FED. ROAD DIST. NO.	STATE	PROJ. NO.	FISCAL YEAR	SHEET NO.	TOTAL SHEETS
HAWAII	HAW.	83D-01-96M	1996	C.O.29	50

△ TYPE "B" UPGRADE

(AT SOUTH KAHANA, NORTH KAHANA, AND SOUTH PUNALUU BRIDGES)

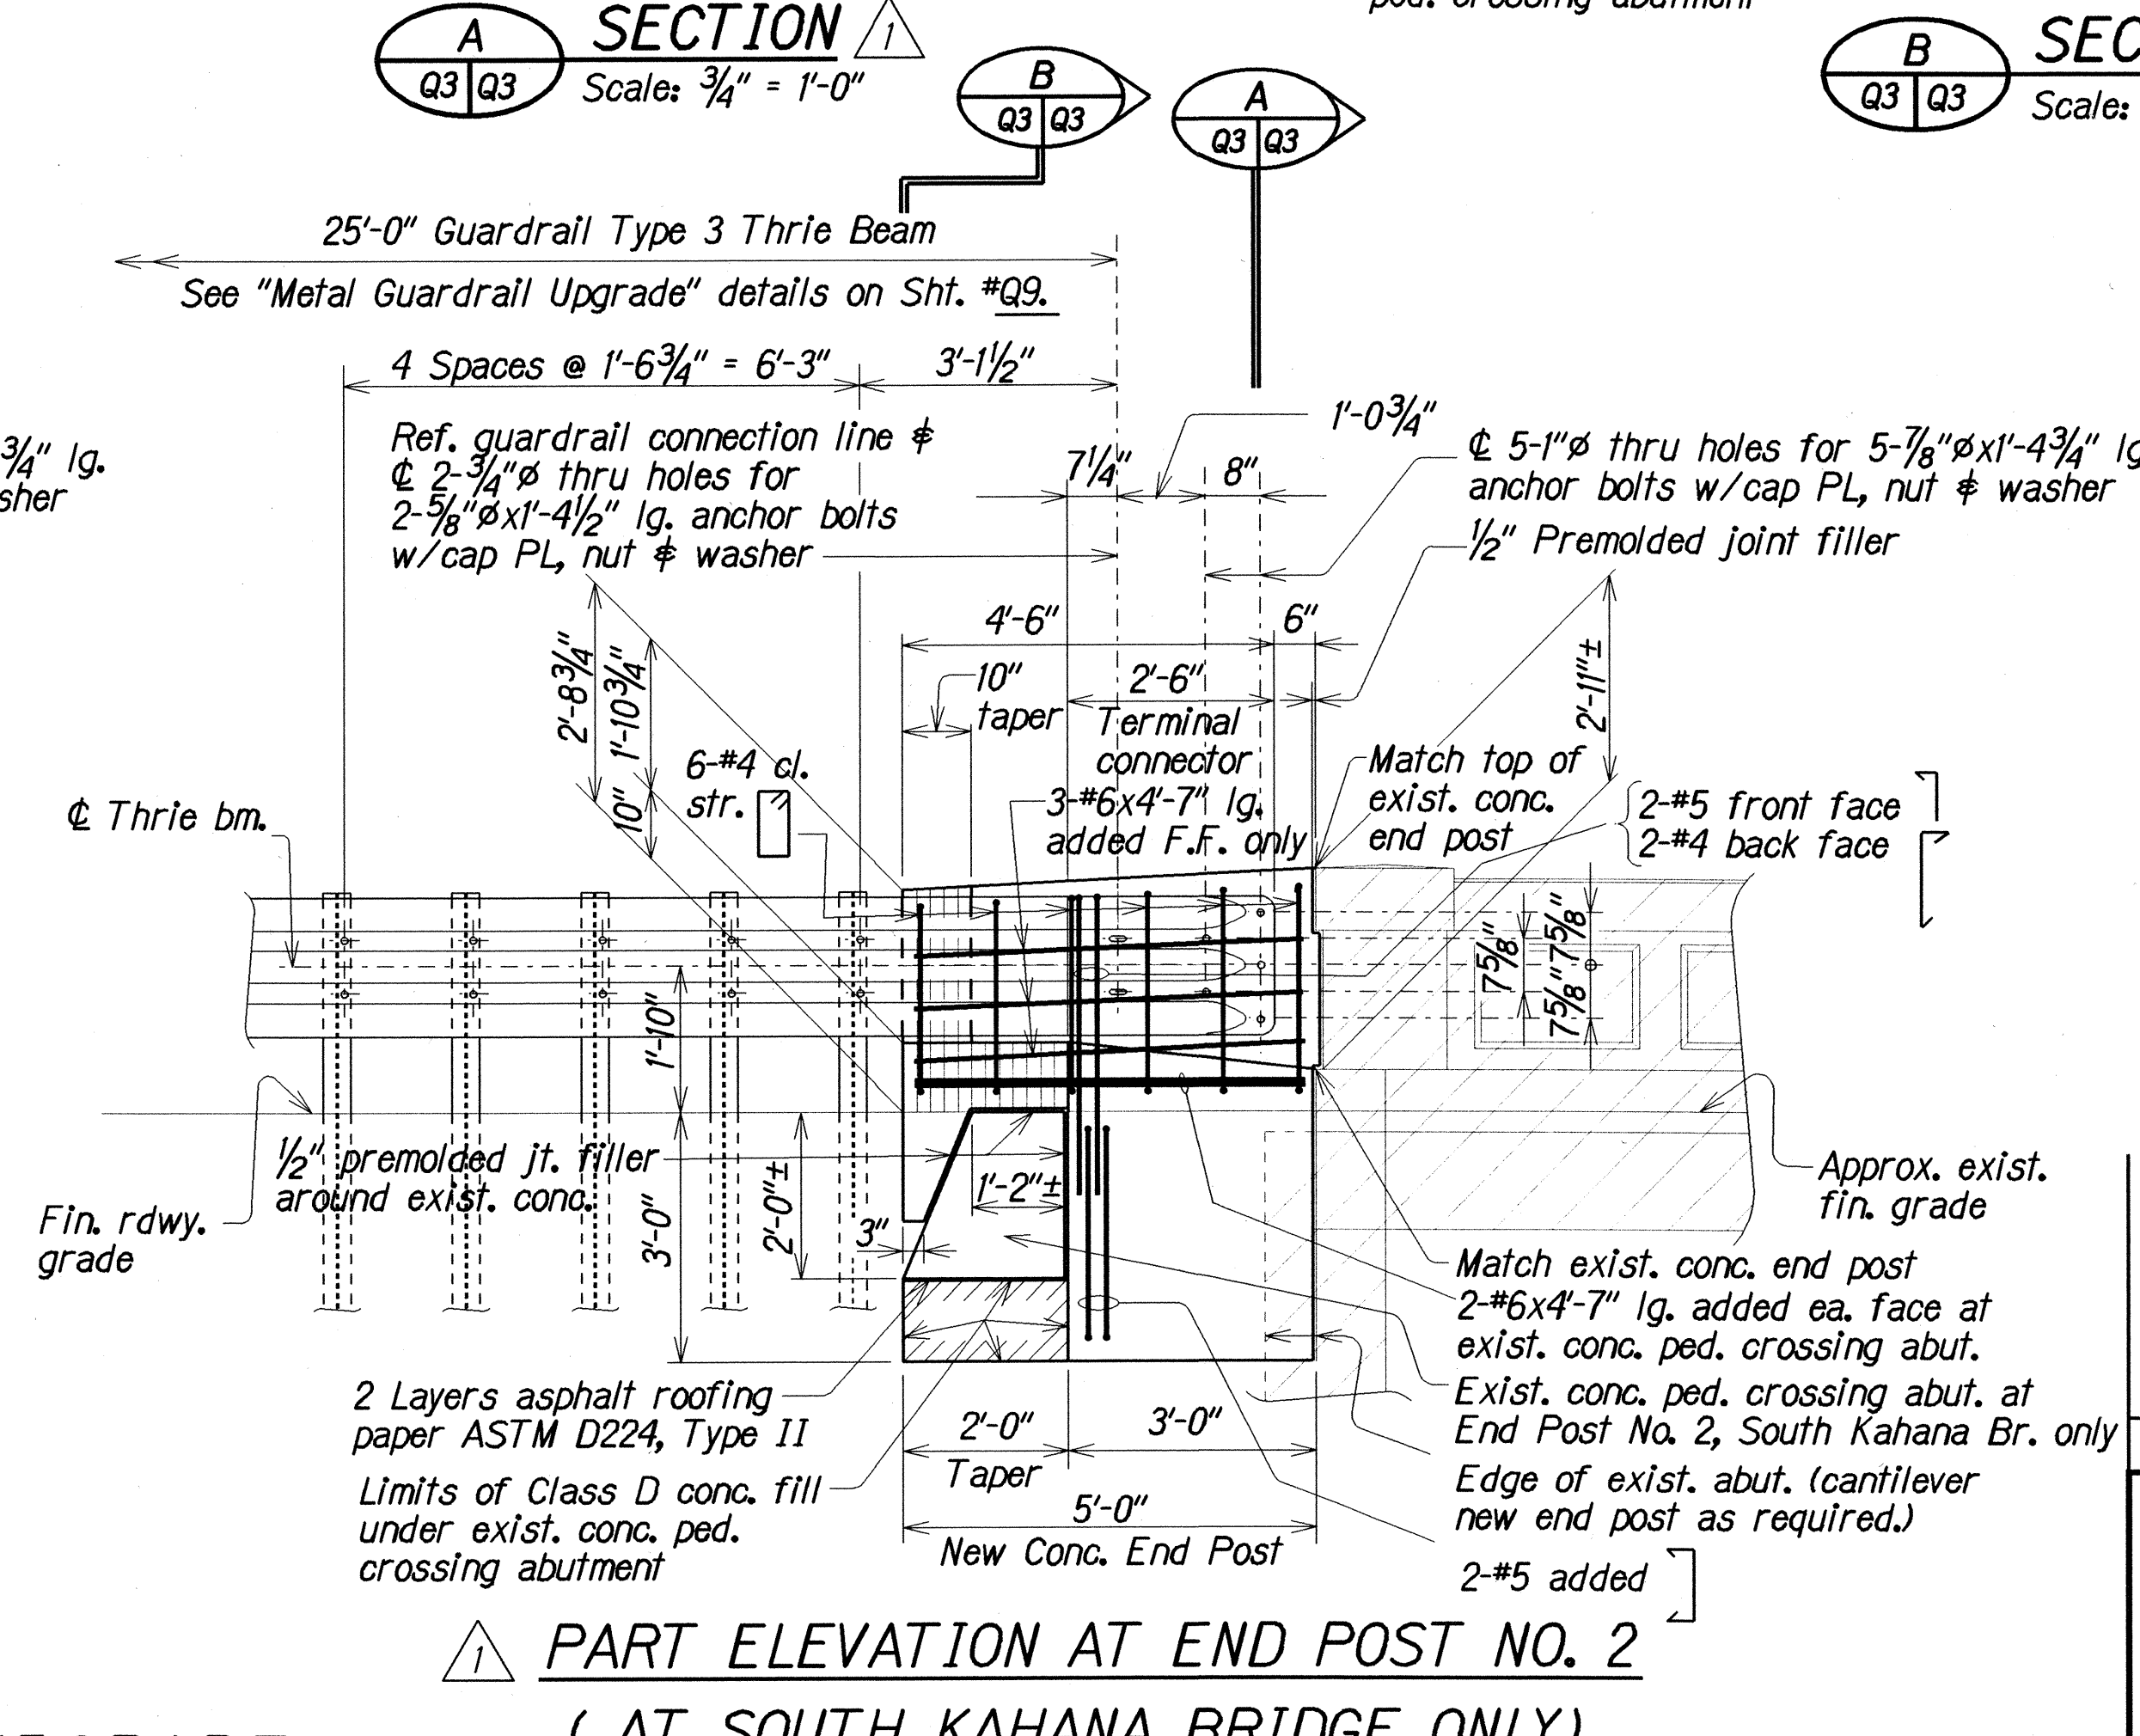
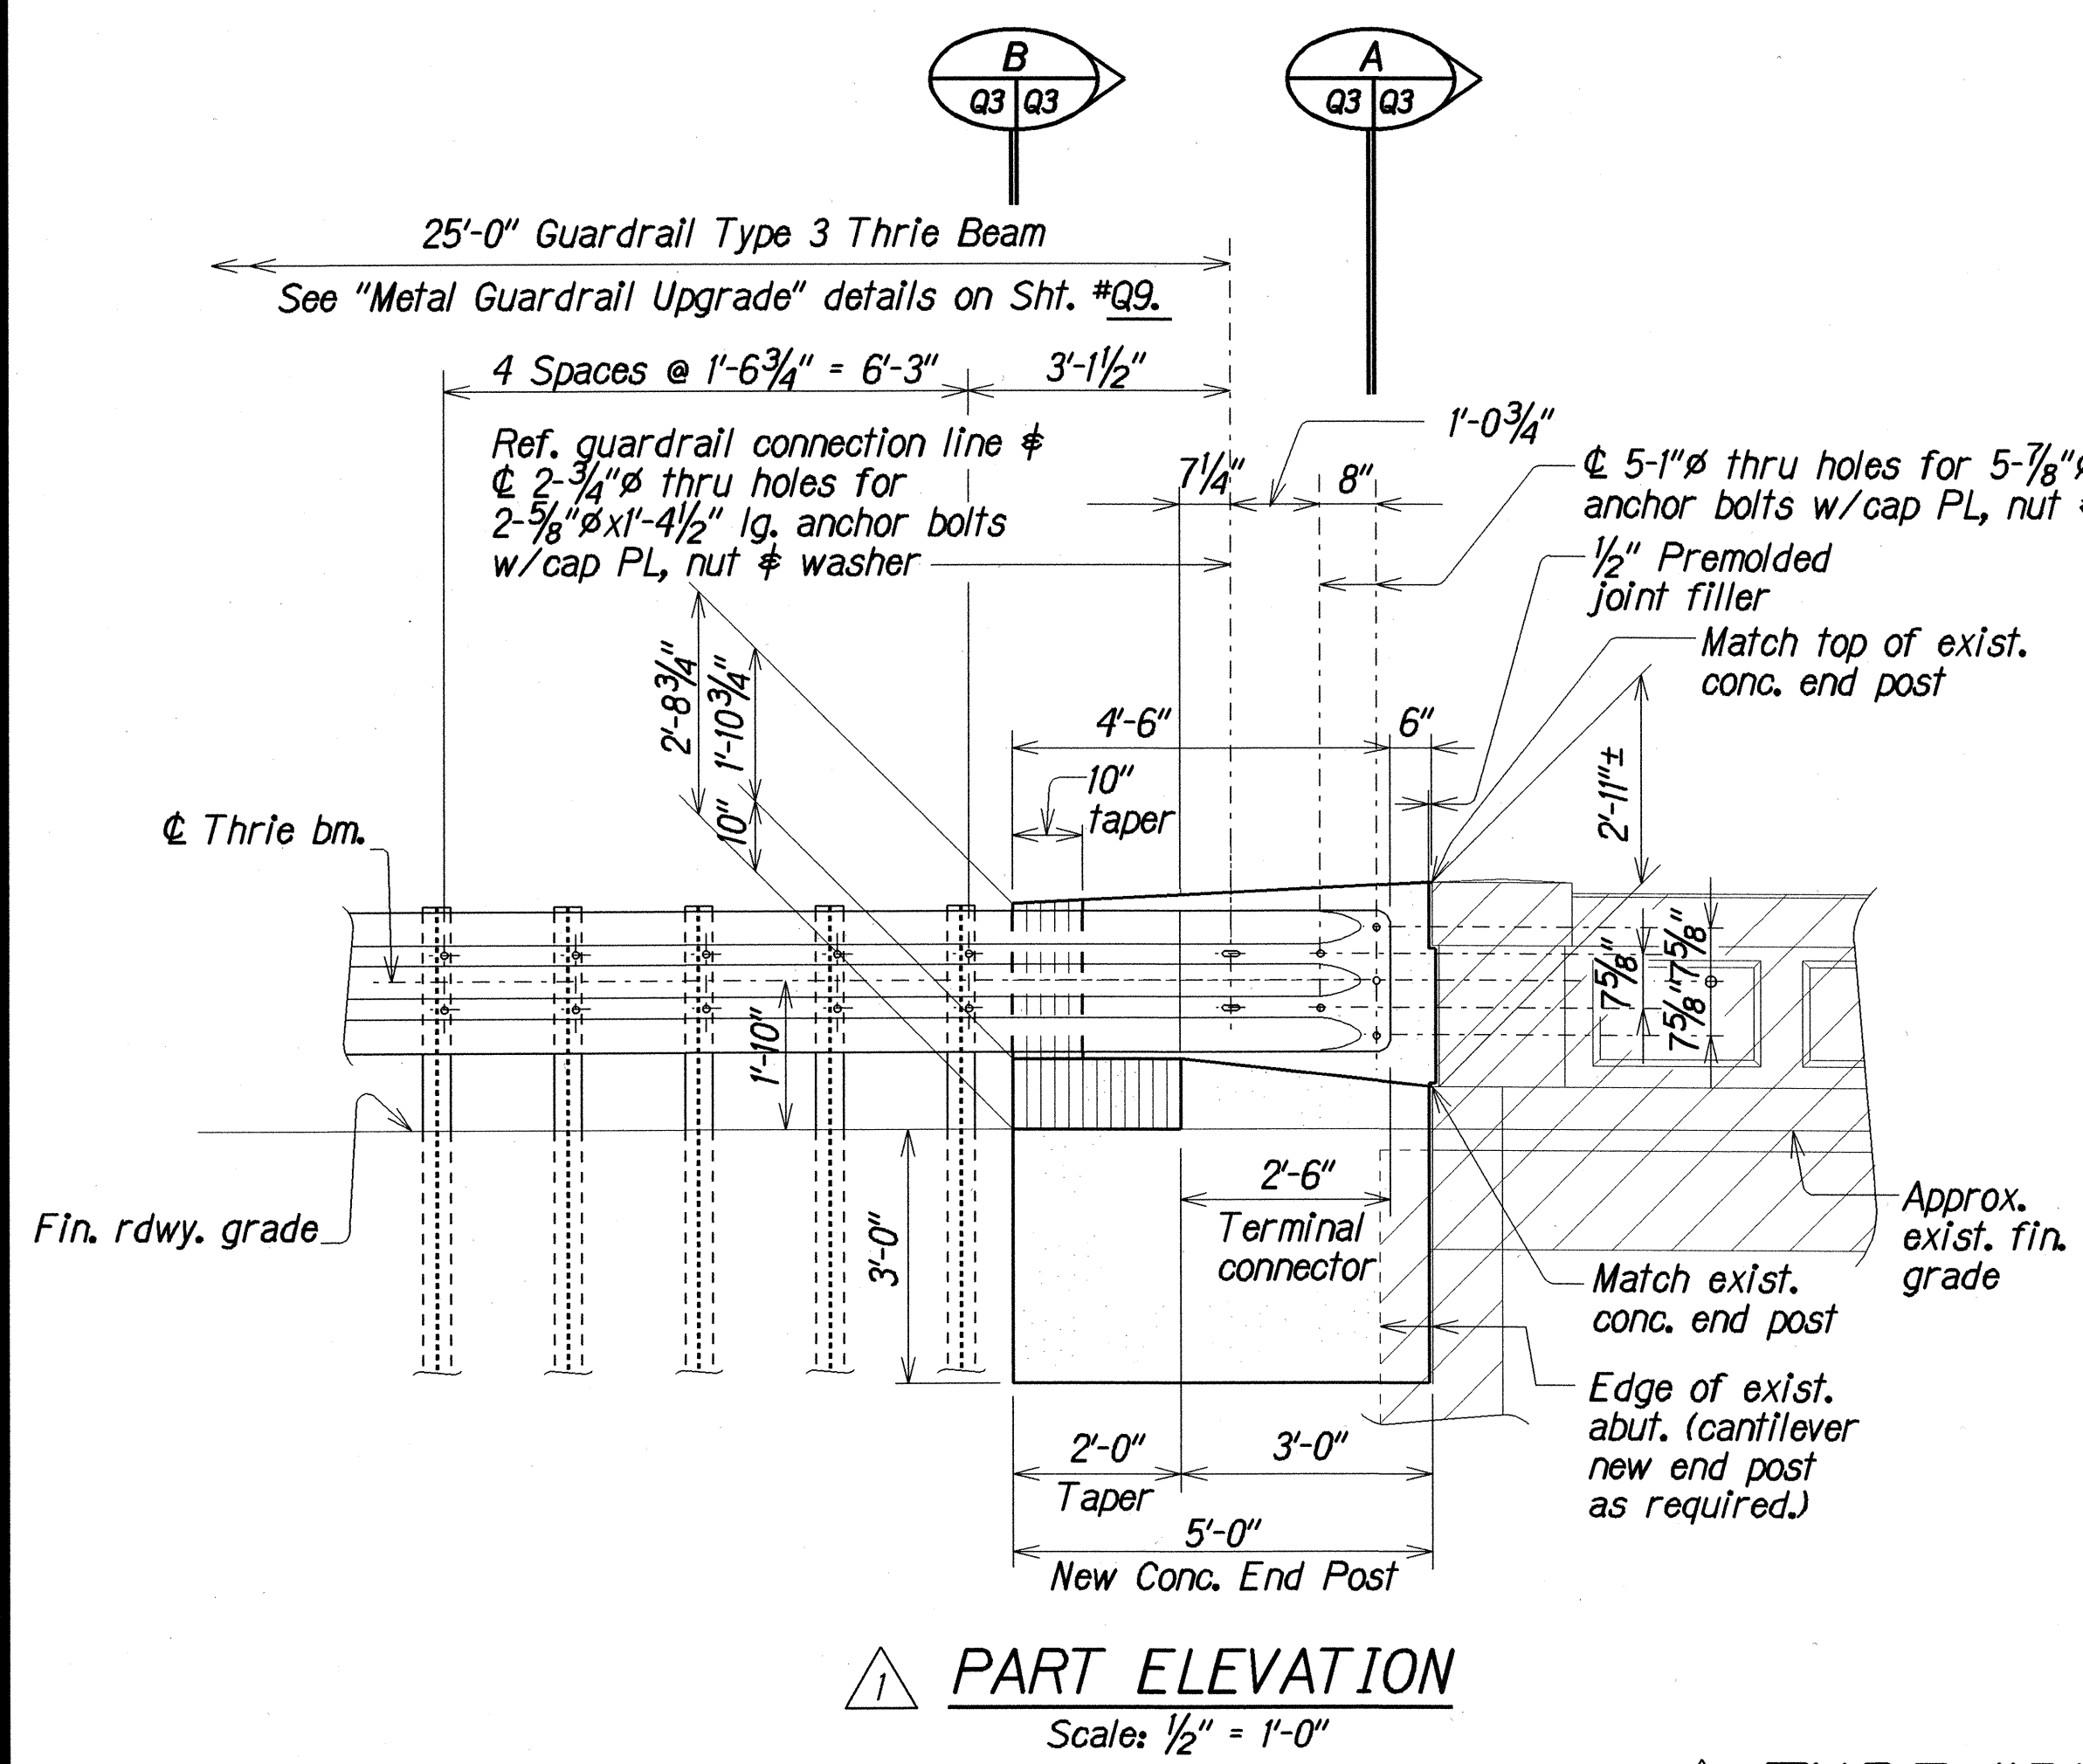
Added detail and information to accommodate exist. conc. ped. crossing abut. at End Post No. 2, South Kahana Bridge. Dimensions, labels and details were moved to make space for additions.	2/11/97
DATE	REVISIONS
STATE OF HAWAII DEPARTMENT OF TRANSPORTATION HIGHWAYS DIVISION SOUTH KAHANA, NORTH KAHANA, AND SOUTH PUNALUU BRIDGES TYPE "B" UPGRADE - END POST CONNECTION KAMEHAMEHA HIGHWAY RESURFACING Crouching Lion to Puhuli Street Project No. 83D-01-96M Scale: As Noted Date: May 1996
